HCCSC Horace Mann Elementary HVAC Replacement

Project # 2025.0014

9-28-2026

ADDENDUM NO. 01

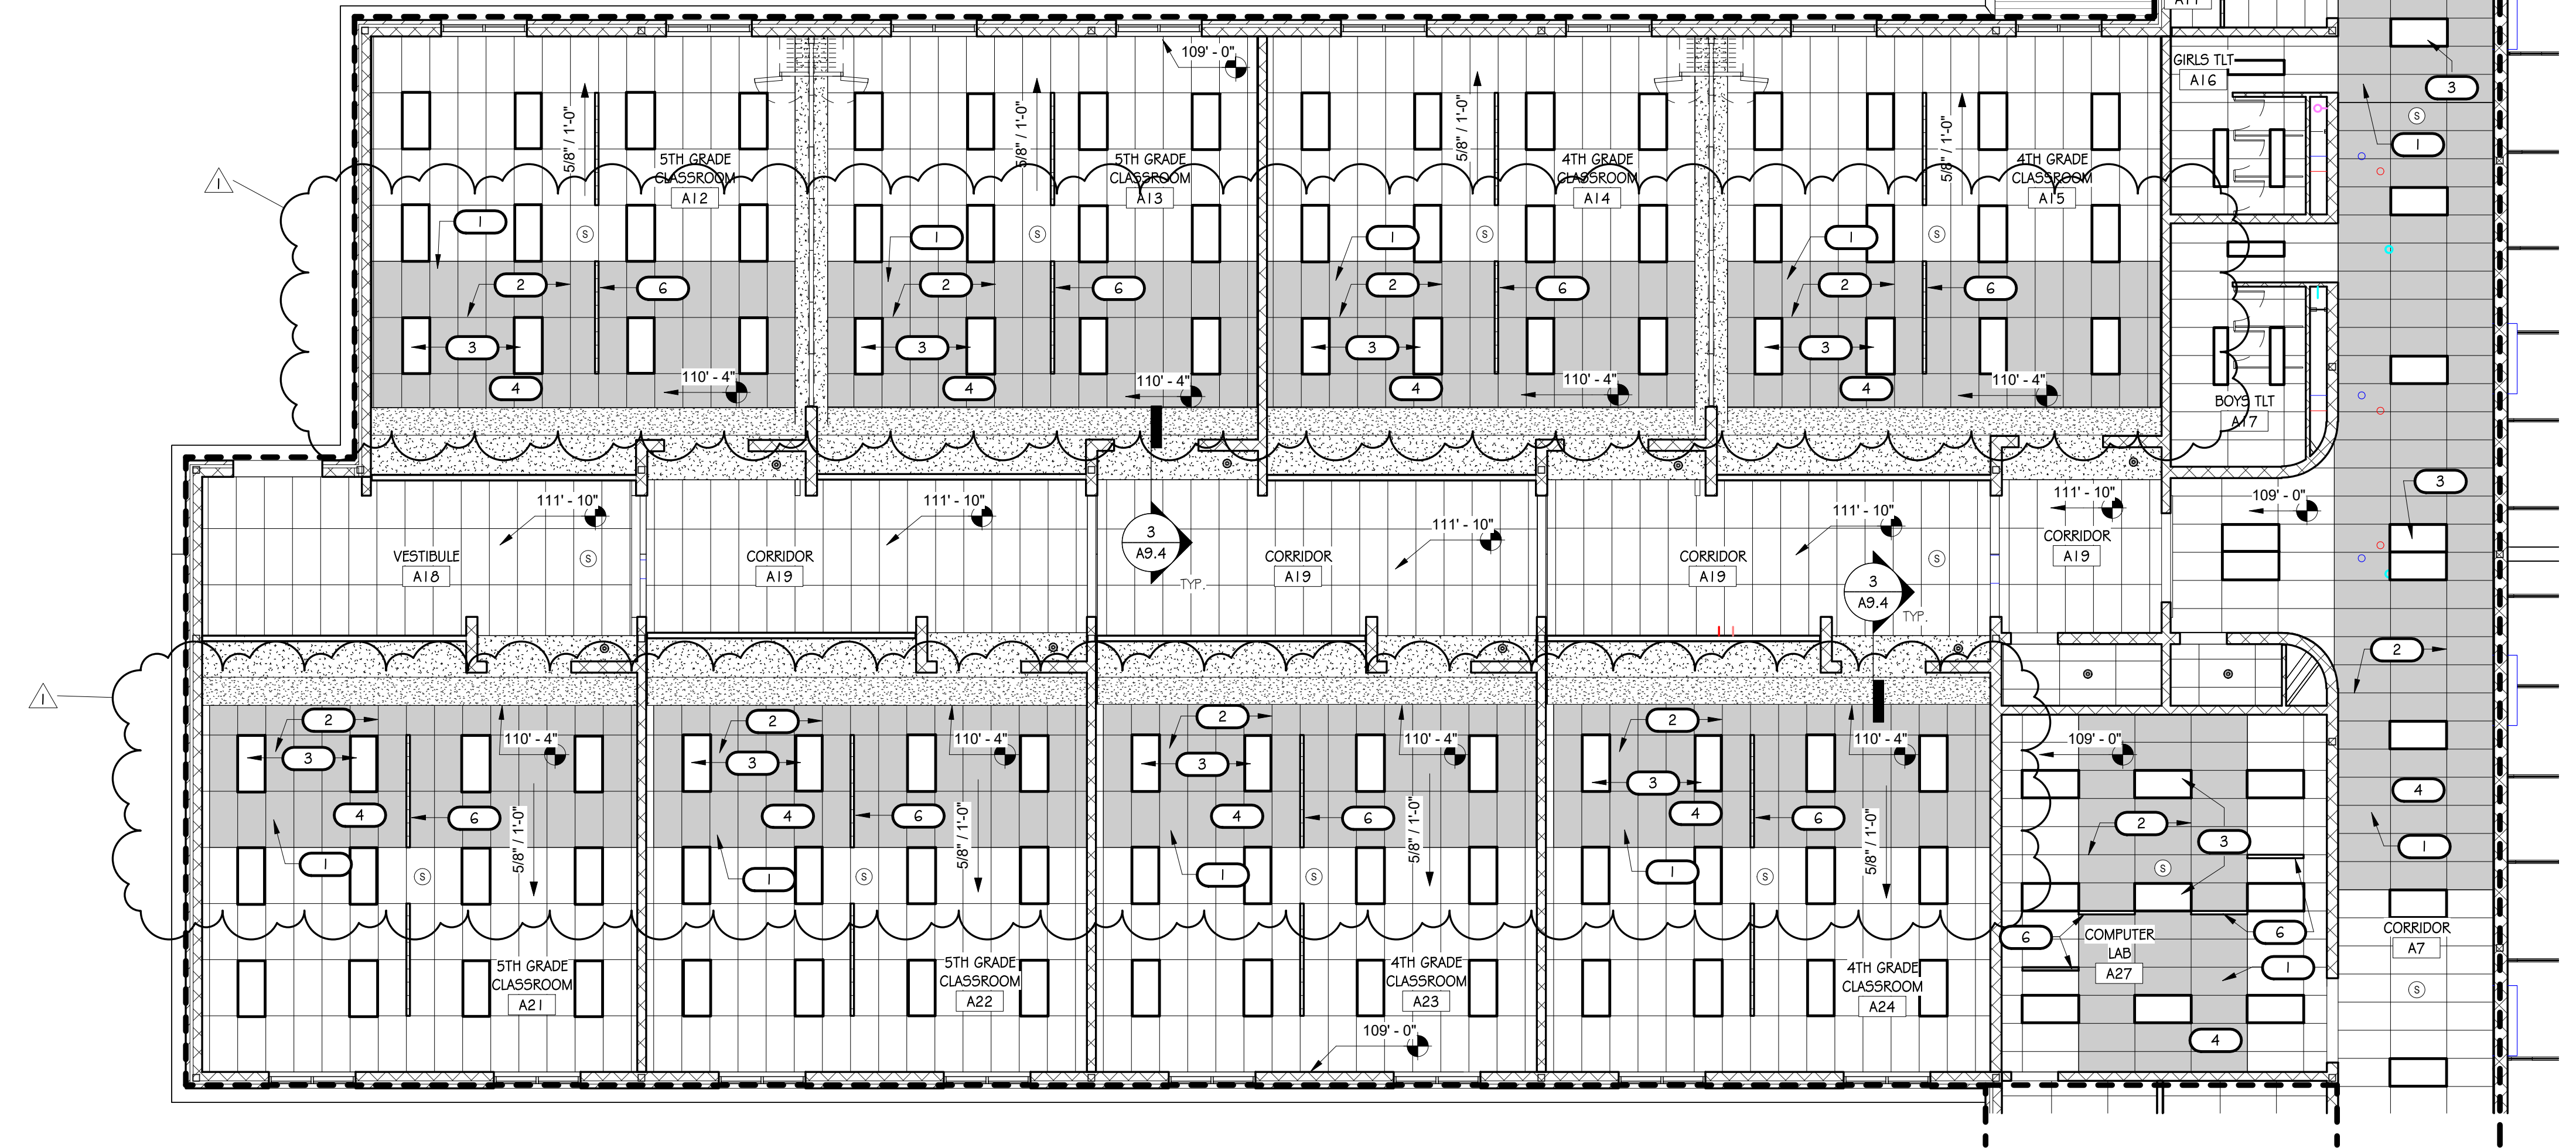
Item: A-1.2
Location: Drawings
Description: Replace existing drawing sheet A9.1 Reflected Ceiling Plan – Unit A, dated 9-21-2026, with Revised drawing sheet A9.1 Reflected Ceiling Plan-Unit A dated 9-28-2026.
Changes: **Revised orientation of removed ceiling panels in Classrooms**

REFLECTED CEILING PLAN - UNIT B
SCALE: 1/8" = 1'-0"

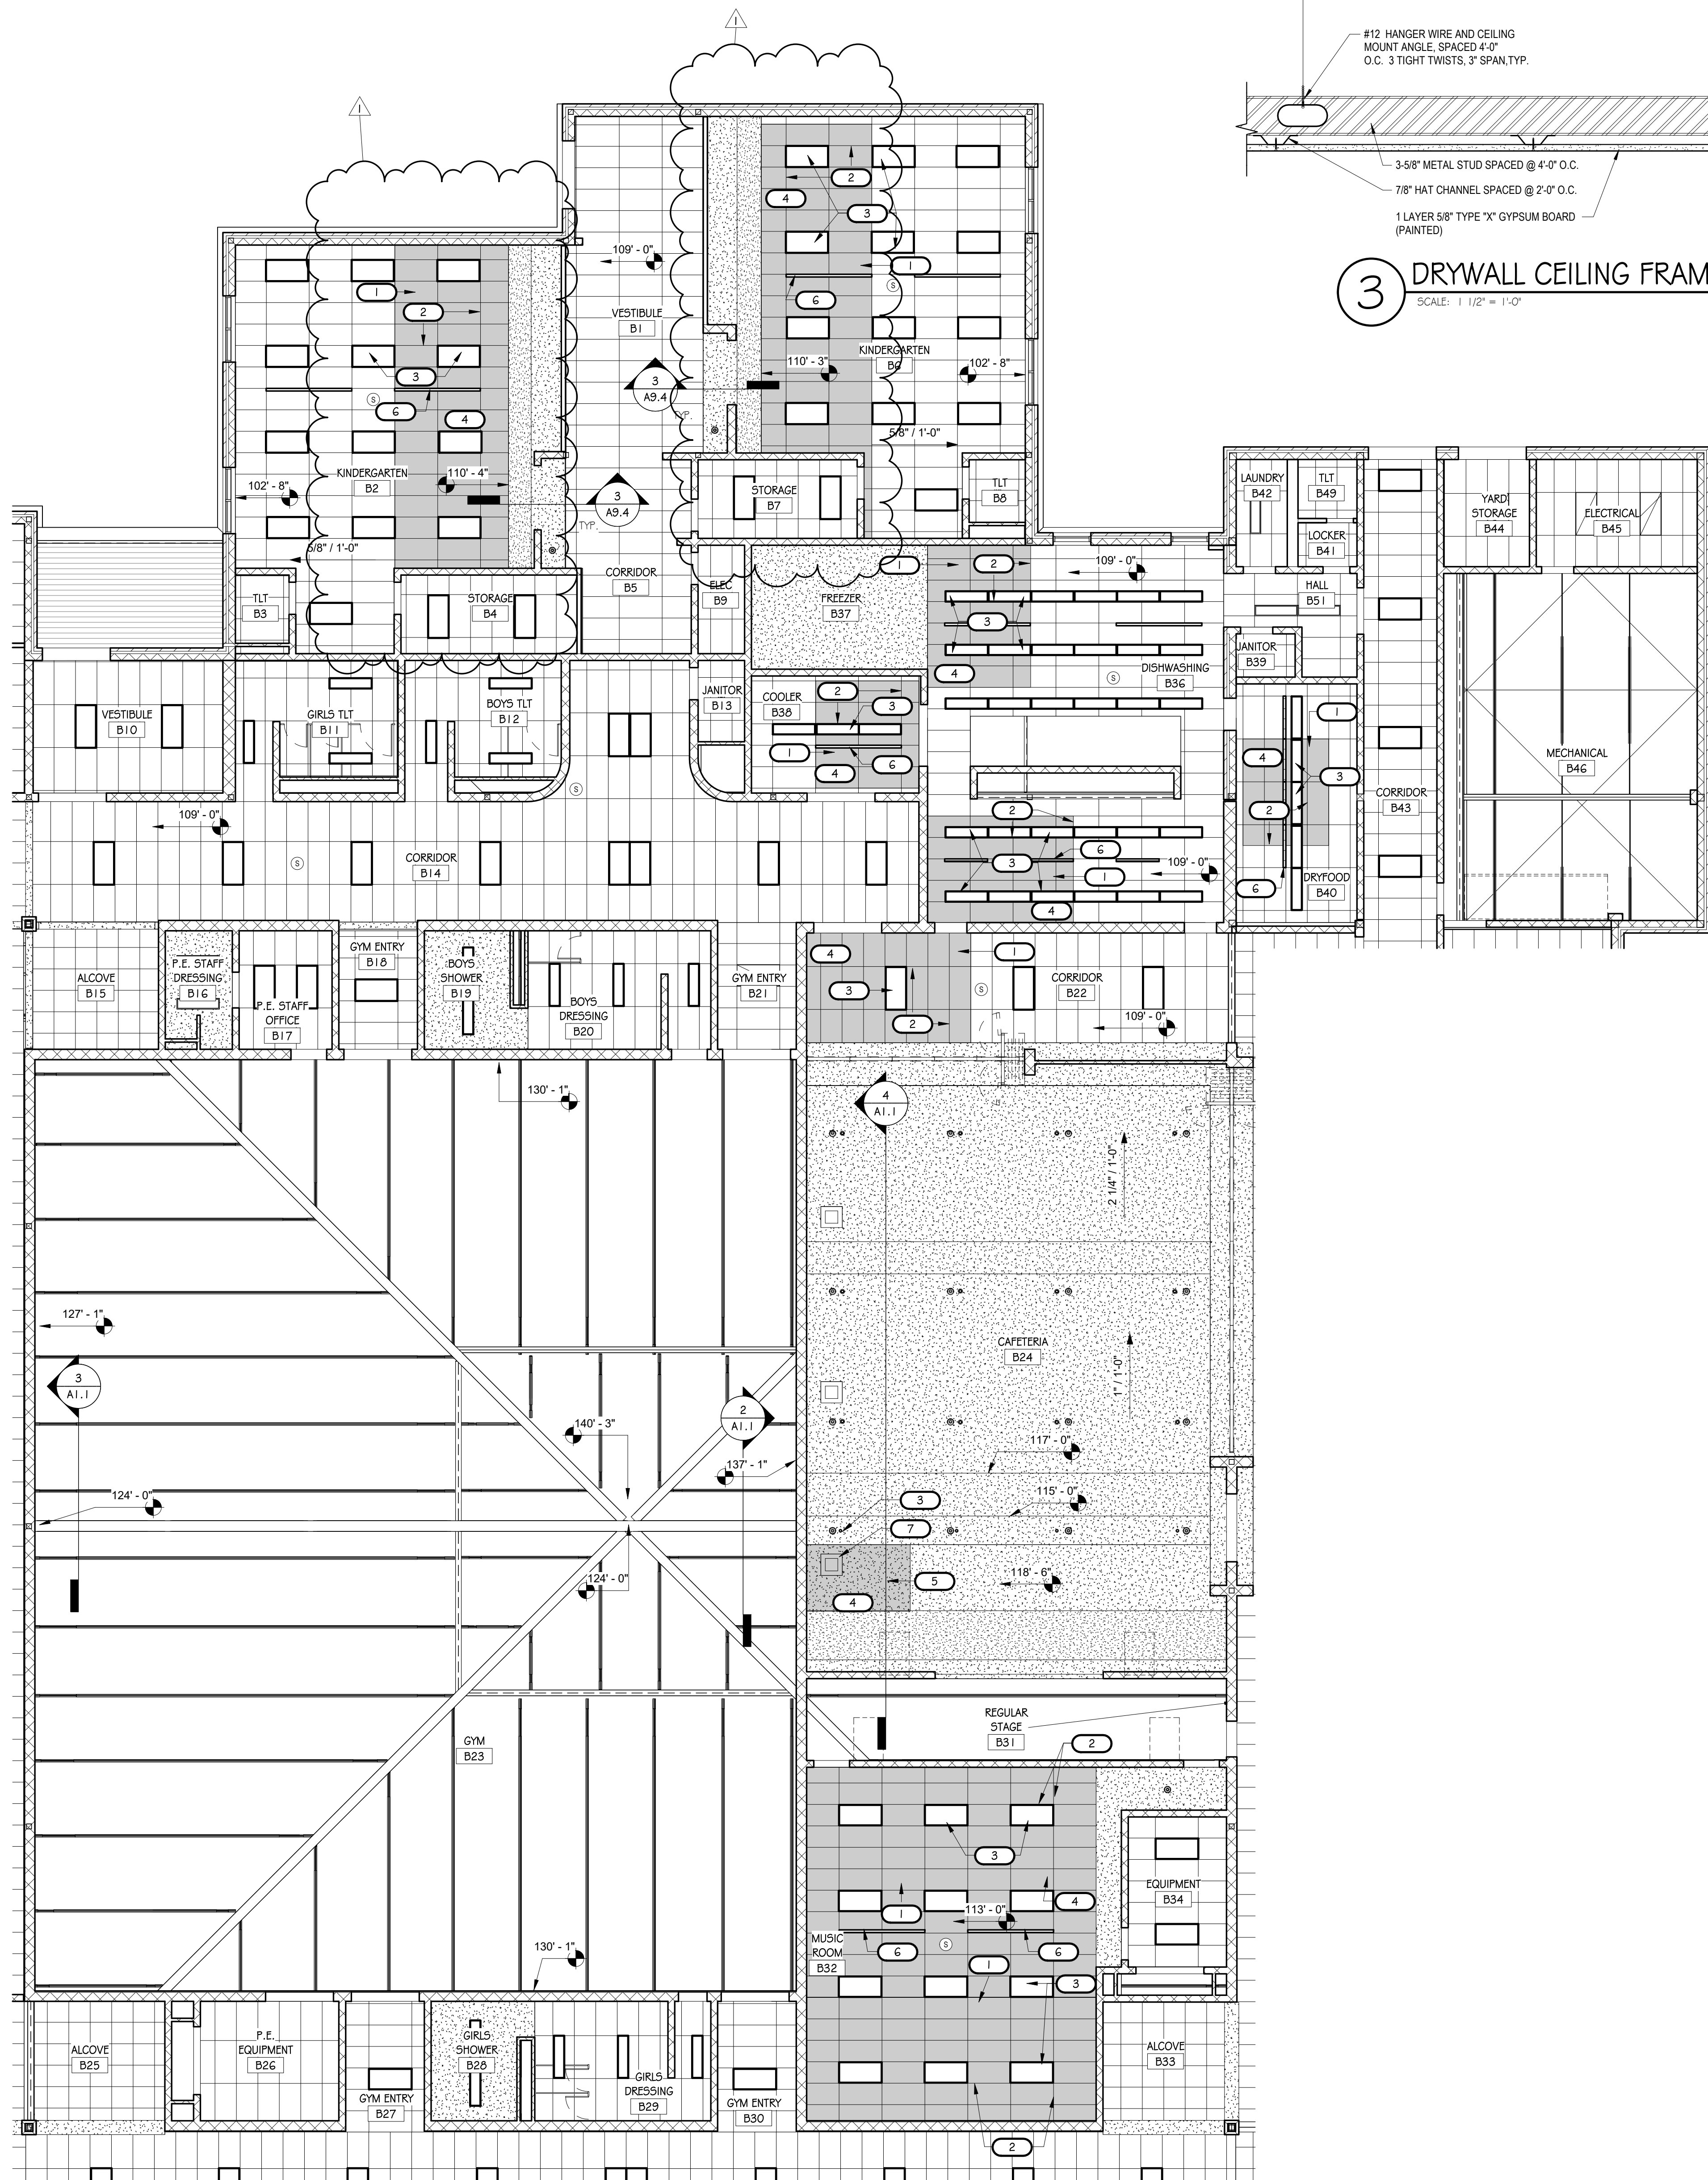
Item: A-1.3
Location: Drawings
Description: Replace existing drawing sheet A9.2 Reflected Ceiling Plan – Unit B, dated 9-21-2026, with Revised drawing sheet A9.2 Reflected Ceiling Plan-Unit B dated 9-28-2026.
Changes: **Revised orientation of removed ceiling panels in Classrooms**

TITLE
REFLECTED CEILING PLAN - UNIT C

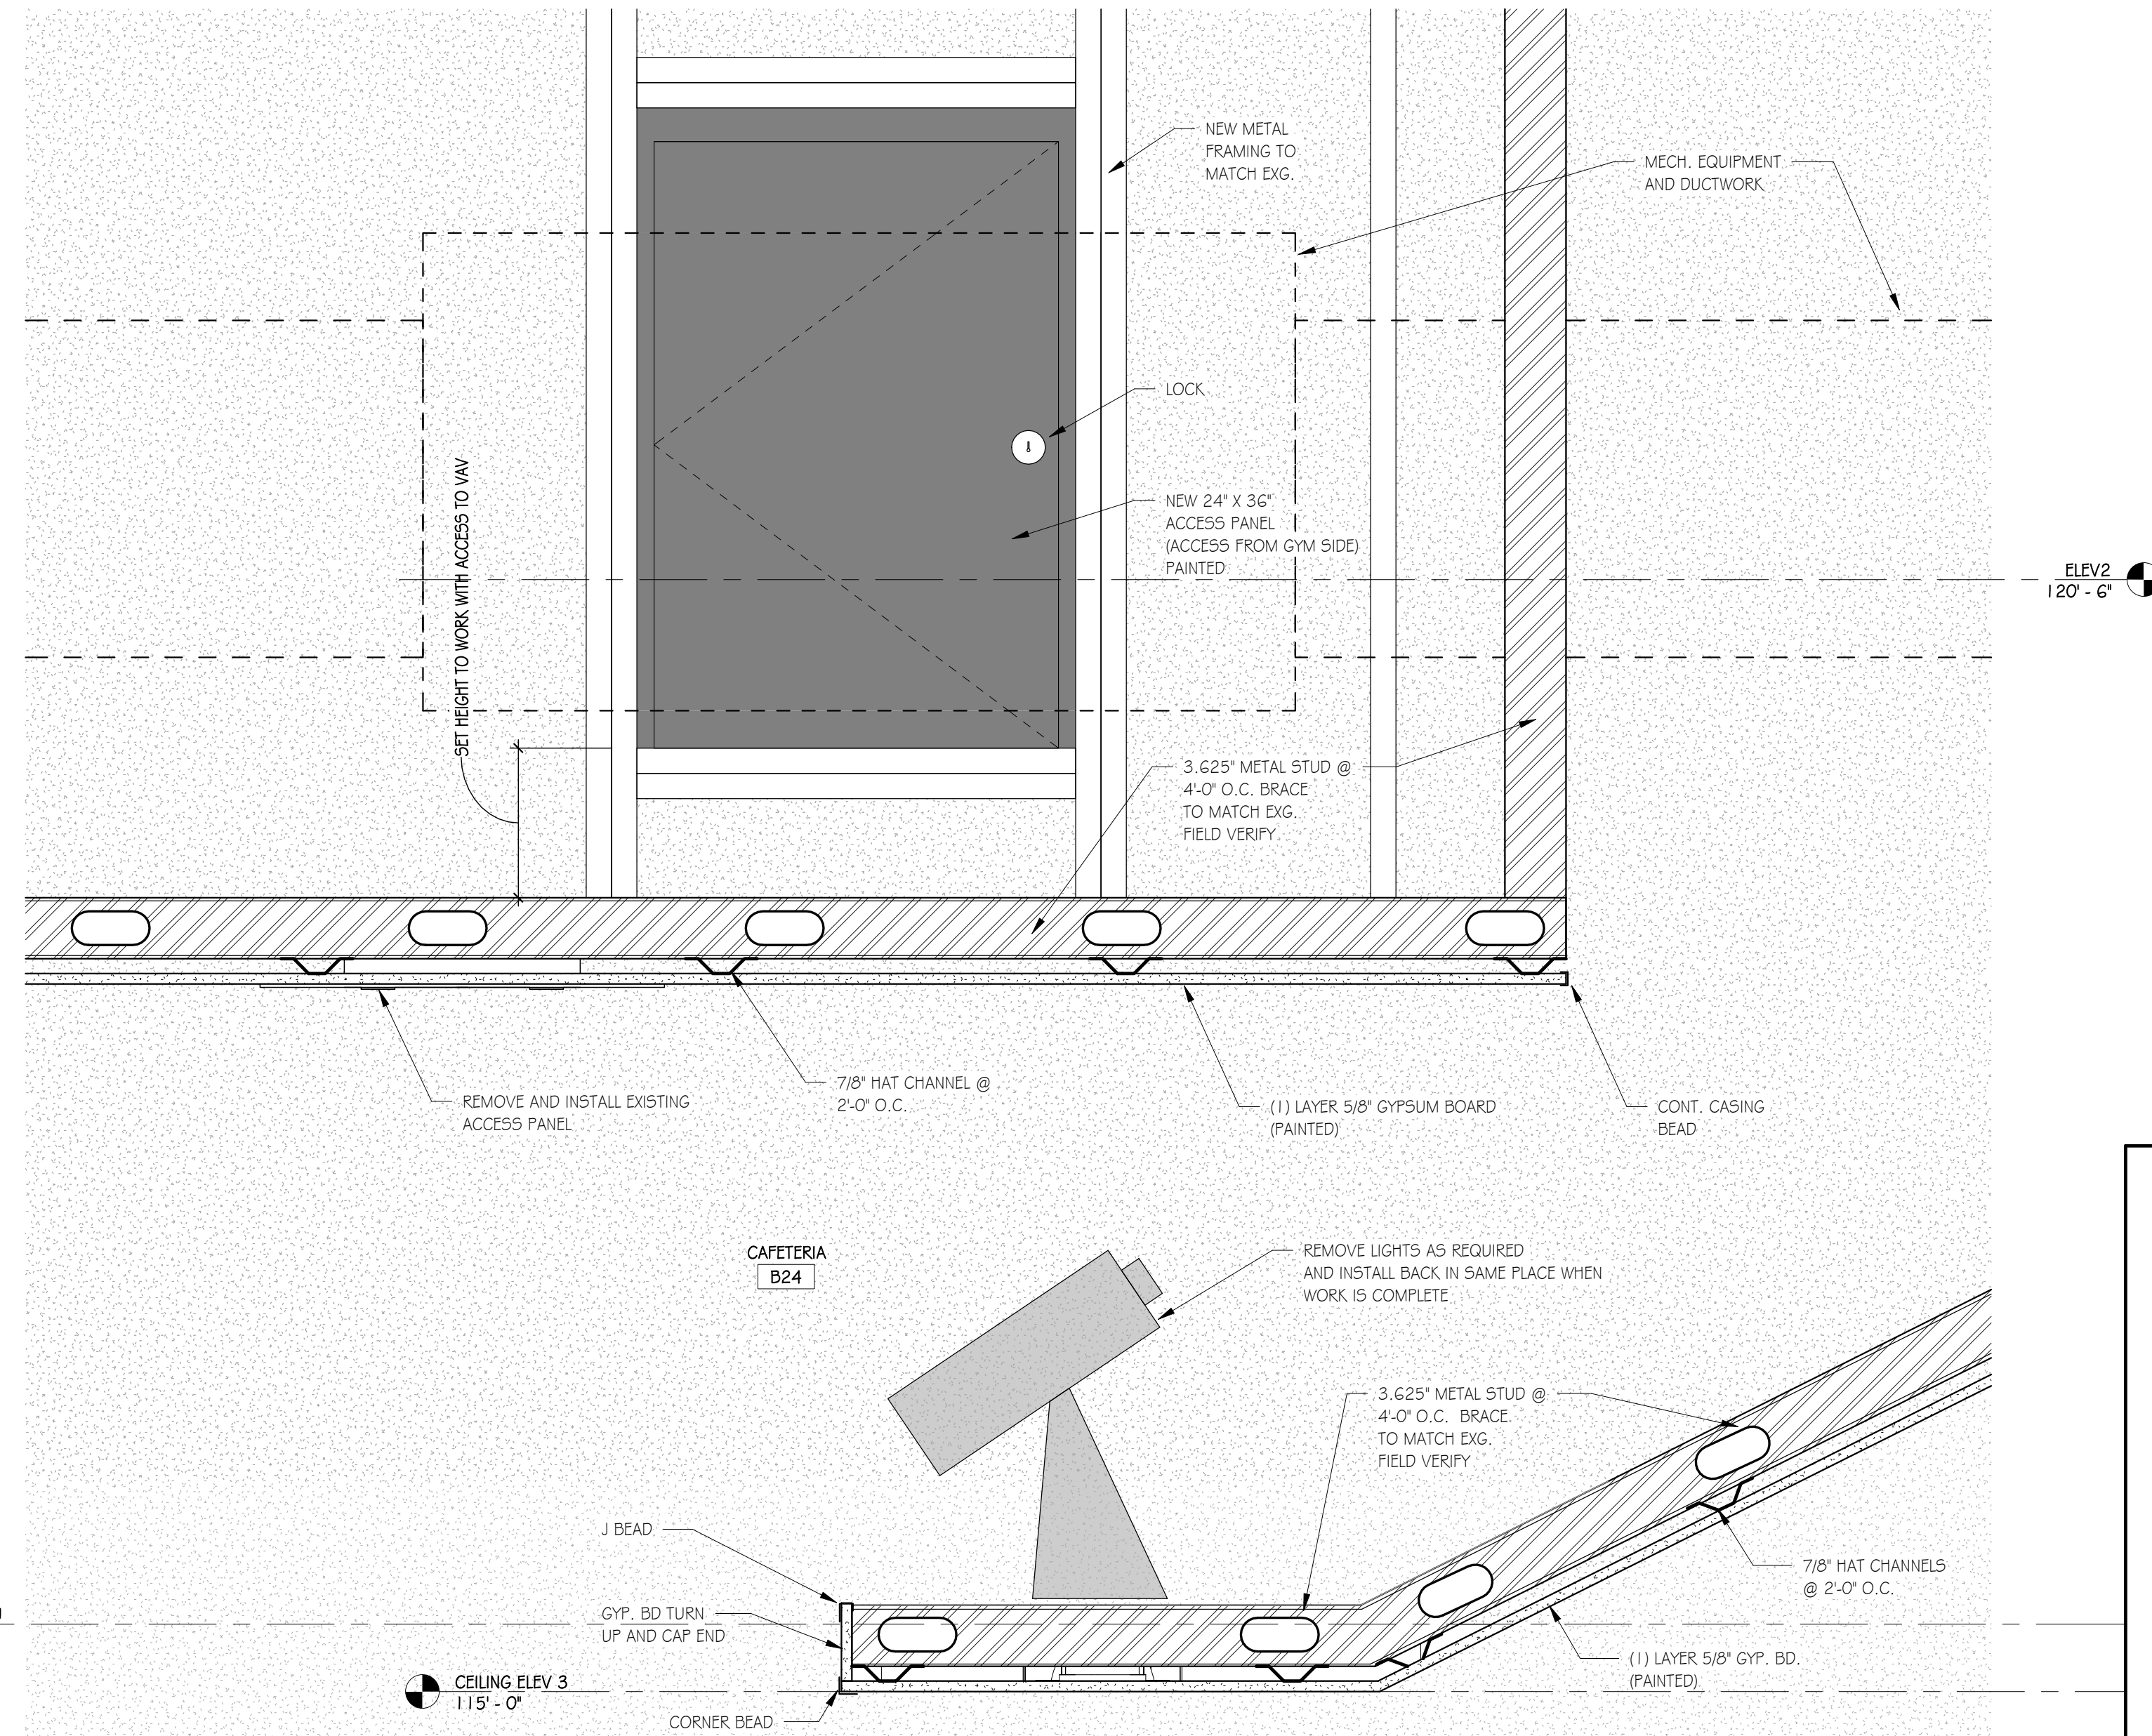
Item: A-1.4
Location: Drawings
Description: Replace existing drawing sheet A9.3 Reflected Ceiling Plan – Unit C, dated 9-21-2026, with Revised drawing sheet A9.3 Reflected Ceiling Plan-Unit C dated 9-28-2026.
Changes: **Revised orientation of removed ceiling panels in Classrooms**
